FINAL SAFETY EVALUATION BY THE OFFICE OF NUCLEAR REACTOR REGULATION

TOPICAL REPORT NEDC-33256P, NEDC-33257P, and NEDC-33258P

“THE PRIME MODEL FOR ANALYSIS OF FUEL ROD

GLOBAL NUCLEAR FUEL – AMERICAS, LLC

Figure 1: Typical BWR Large Break LOCA PCT Transient (from NEDE-23785-1-PA)

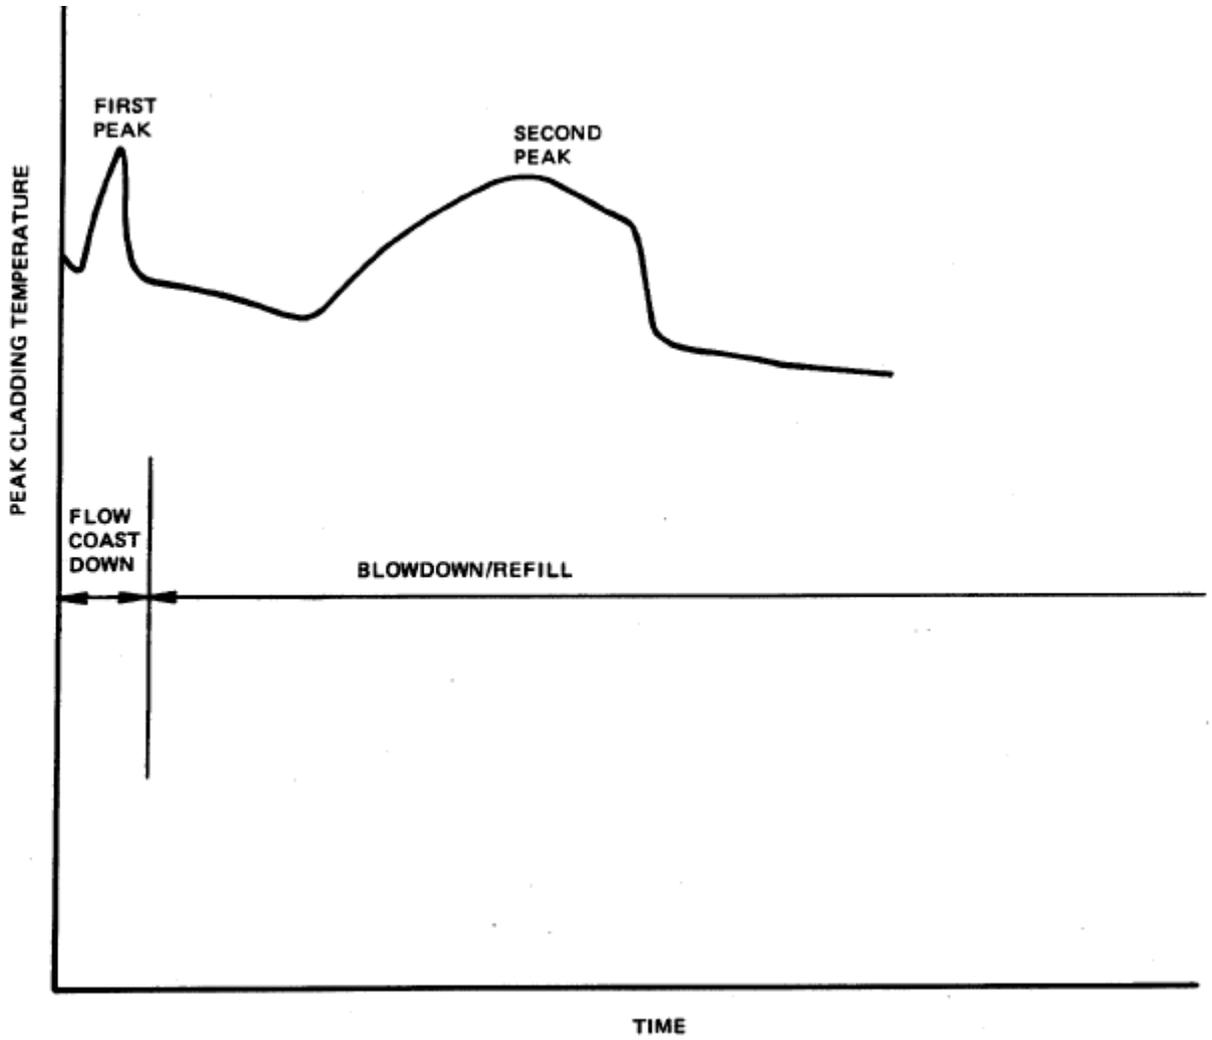
For BWR/3-6 plants, the limiting DBA LOCA break occurs in the recirculation suction line. During the LOCA event, the core flow stagnates after a few seconds due to uncovering of the jet pumps. The stagnation results in two phase separation and the formation of a liquid level in the core. The core is subject to transition boiling during the flow stagnation period. The occurrence of early transition boiling results in an early (or first) peak in the PCT. The level in the core is restored once depressurization occurs when the break uncovers. The level then drops due to mass loss through the break, uncovering the core. The second peak in PCT occurs when the core becomes uncovered. A representative trace of PCT is provided in Figure 1.

The magnitude of the first peak PCT is primarily a function of the stored energy as this dictates when the fuel enters boiling transition during the flow stagnation. The effectiveness of the depressurization to remove the energy makes the second peak PCT magnitude much more dependent on the relative capability of the ECCS to inject coolant and the amount of decay heat being generated within the core.
